| marantz® SERVICE BULLETIN | | Date: 10-Dec.-2004 | Model: CD5400 |
| | | Subject: The sound jump sometimes occurs during Playback CD. | |

[PHENOMENON]

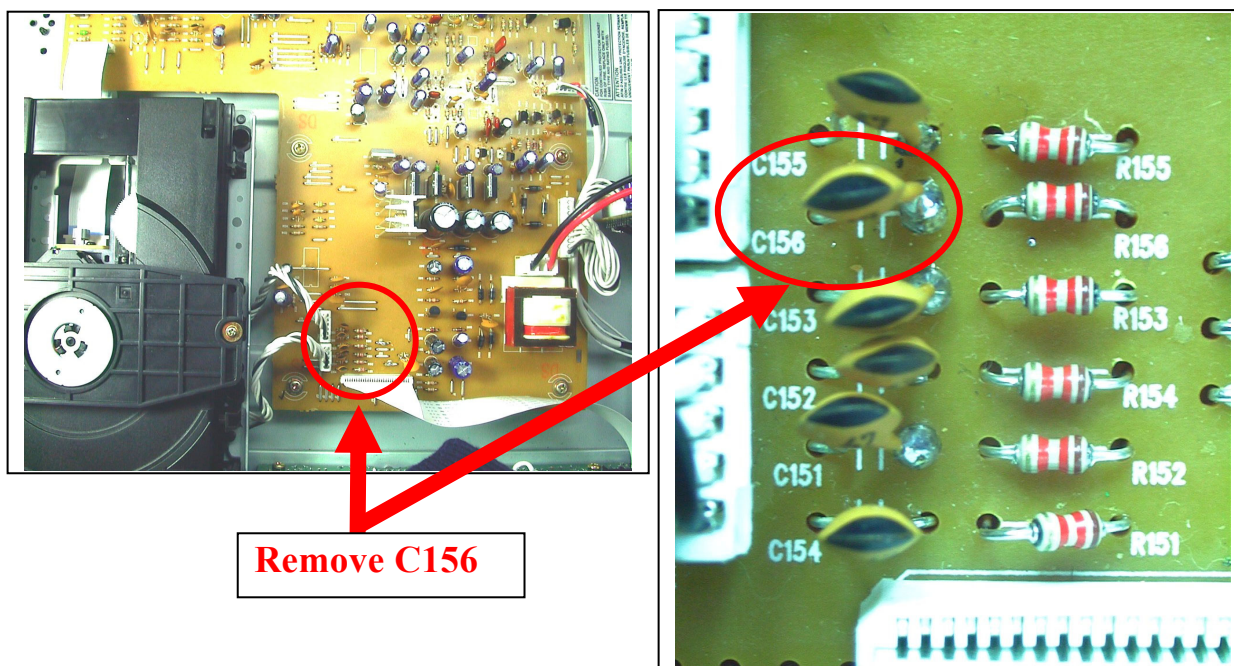
When playback CD, the sound jump sometimes occurs.

C156 Capacitor connected to the CLOCK line of DSP changed the signal, and microprocessor cannot recognize correct data.

POS.NO C156 (Ceramic Capacitor 47pF) is removed.
